ADDENDUM

No. 04 **Date:** 9/18/2024
Project No. 0020711.01 **Attention:** Leonard D'Souza
Project Name: Princess Margaret Cancer Centre
Stem Cell Transplant 2, MHC, MHDU, DSC
Address: University Health Network
610 University Avenue
Toronto ON

The following architectural questions have been received by the Bidder(s) and the following answers are being provided to all Bidder(s).

A0501

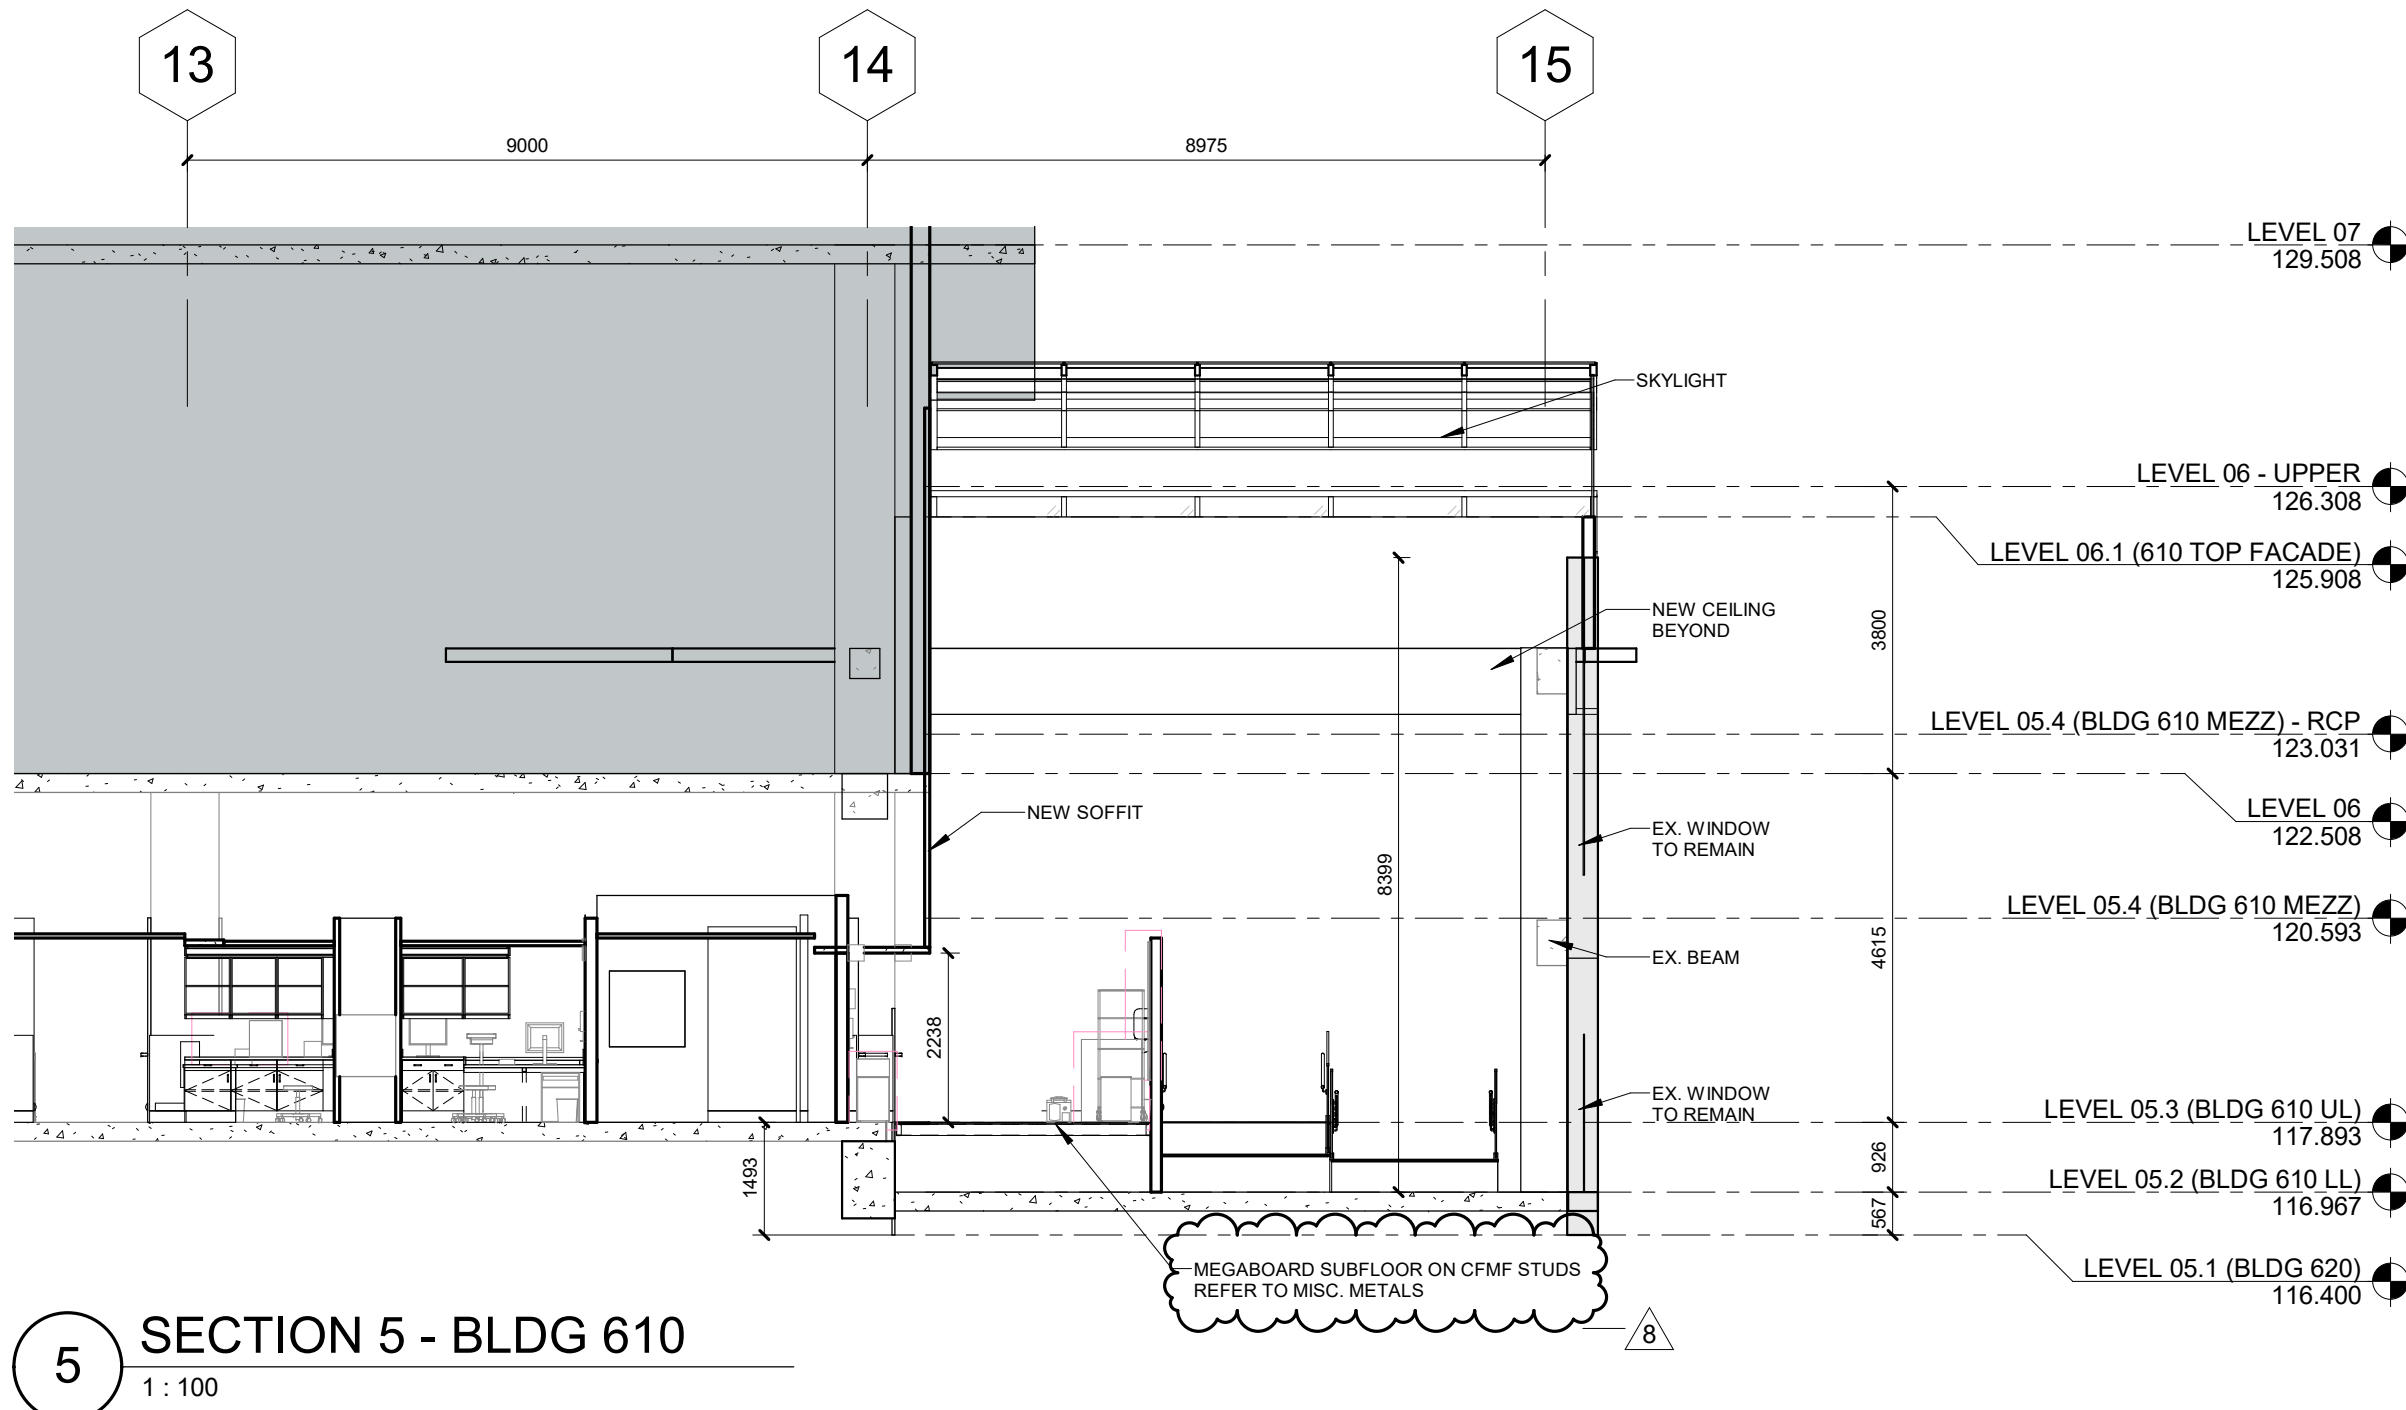
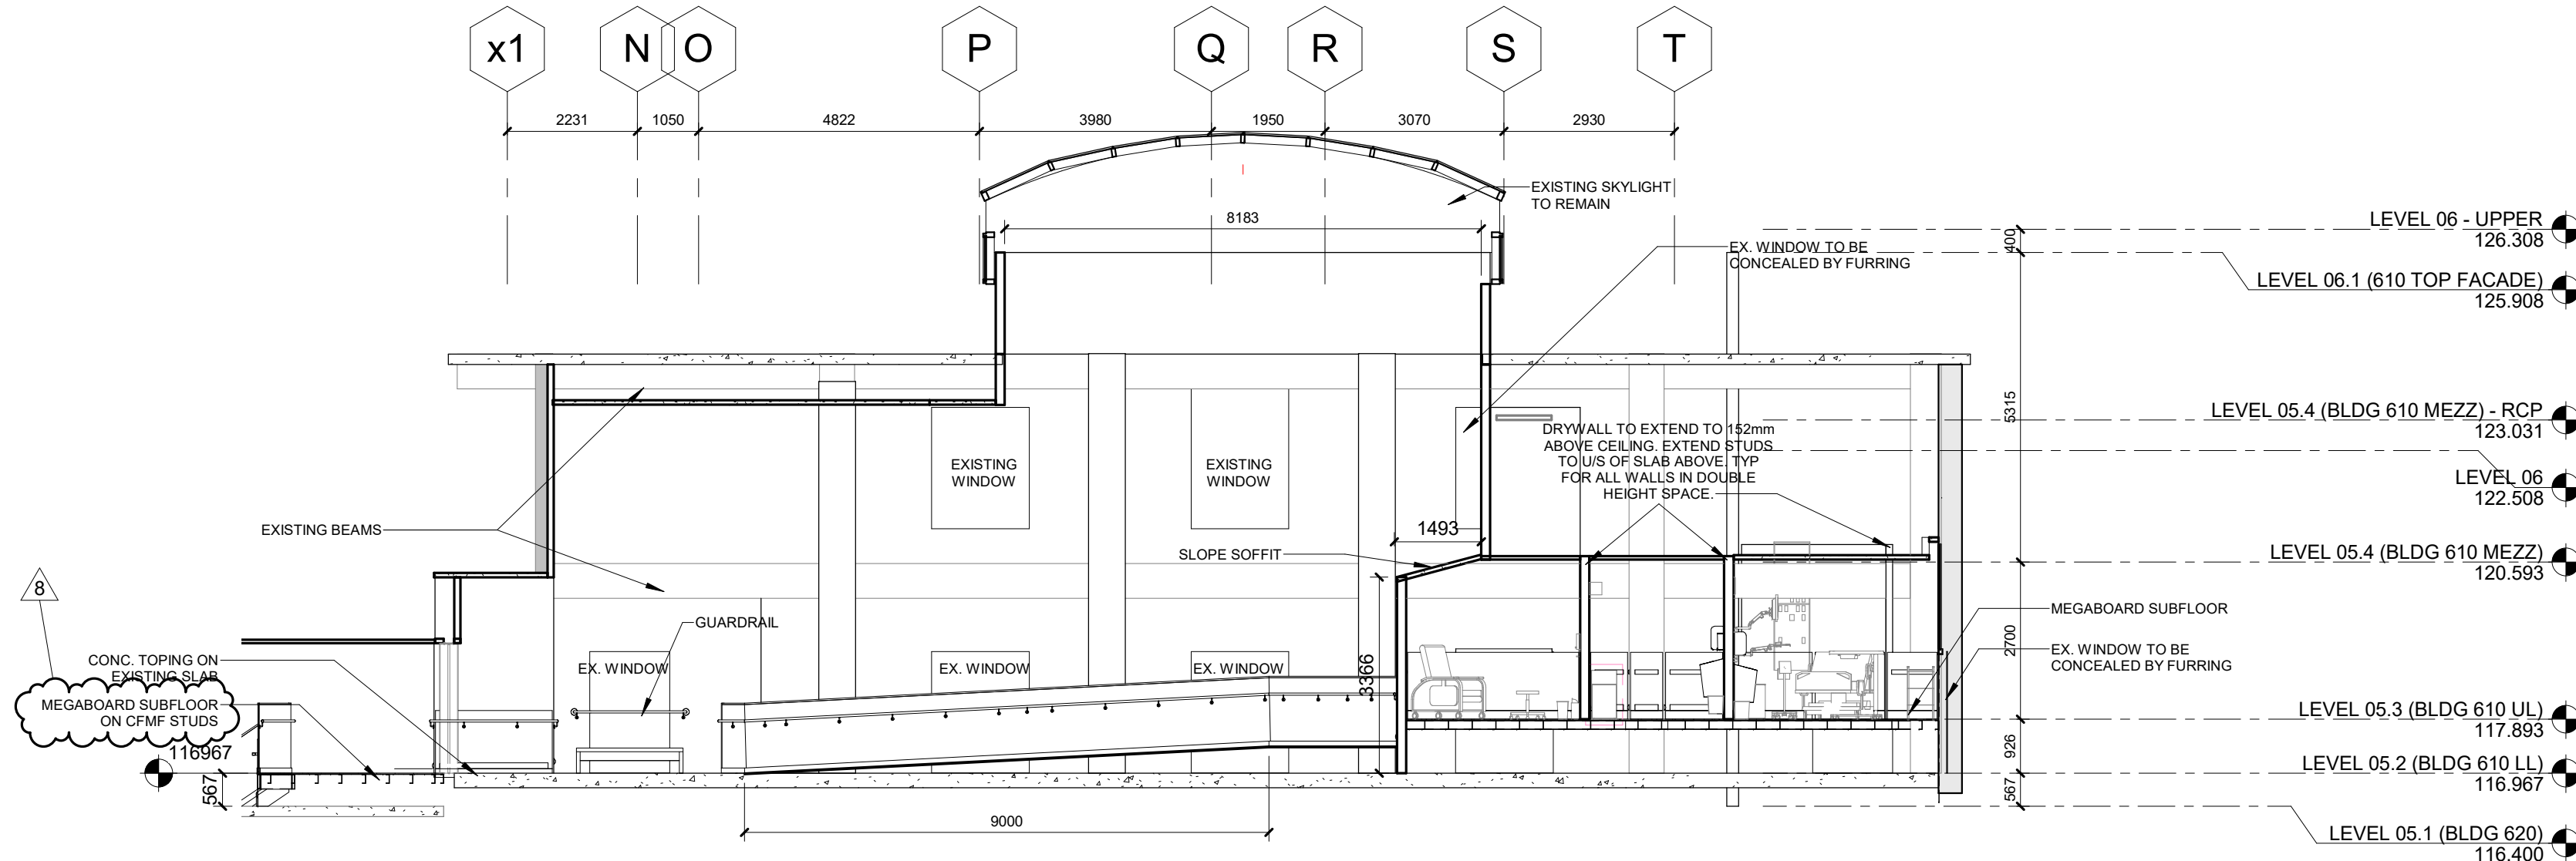
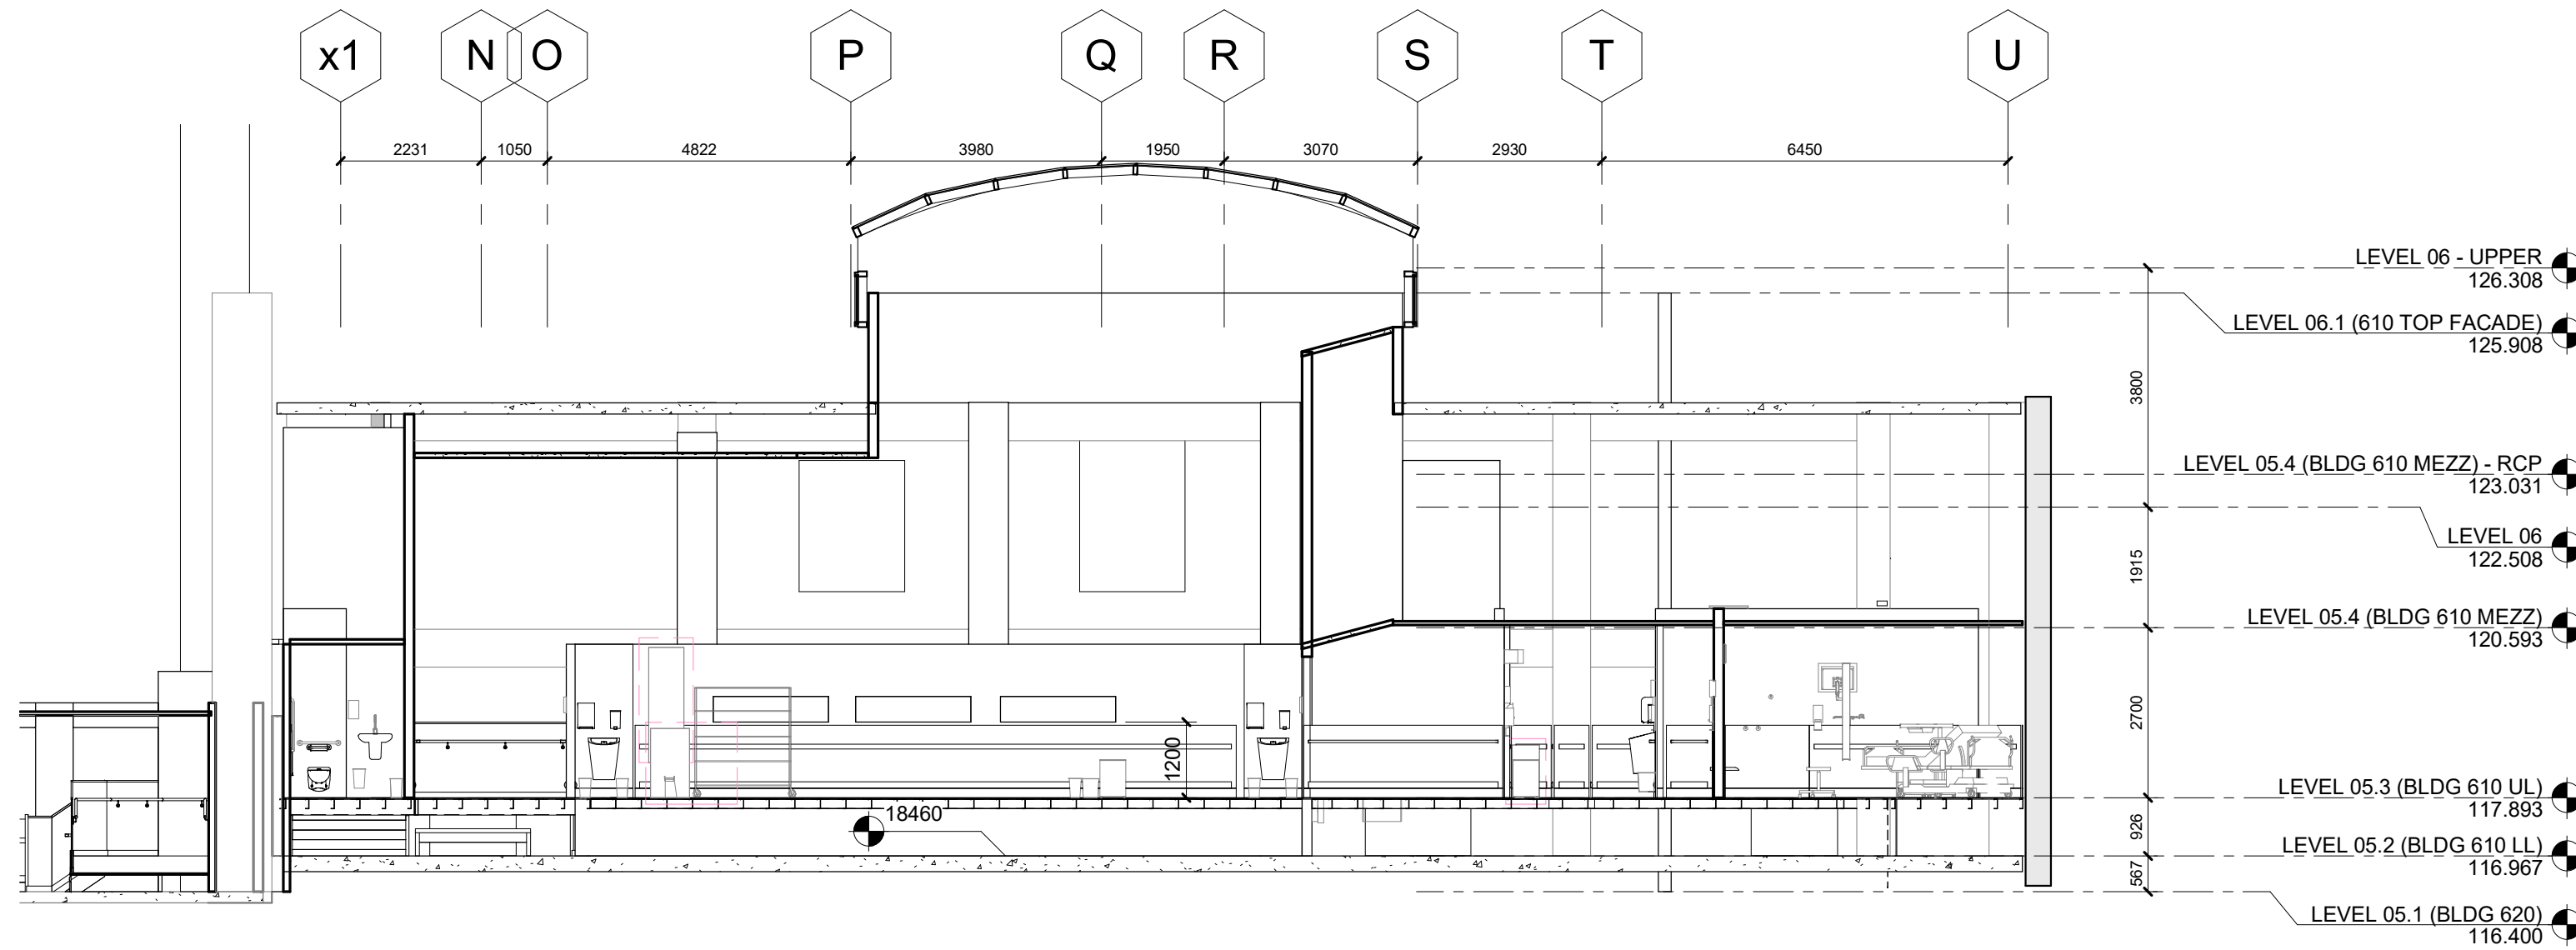
48. (414) (Dwg A0504, S0002) Dwg A0504 detail 1 & 5 show Steel Channel (by Misc. Metal trade) attached to Structural stud framing (by drywall trade). The structural dwg S0002 details A, B, C & D do not show any Misc. Metal support. Please confirm the provided details are correct and if steel channel are required, please provide the size and detail.

Response: Glass guardrails at floor and ramp edges are supported HSS10x2x1/4 (51x254mm) as shown in the detail 2/A0504 and the HSS tube locations have been

specified in the detail 1/A0501. Engineered shop drawings submittal to include glass guard rails.
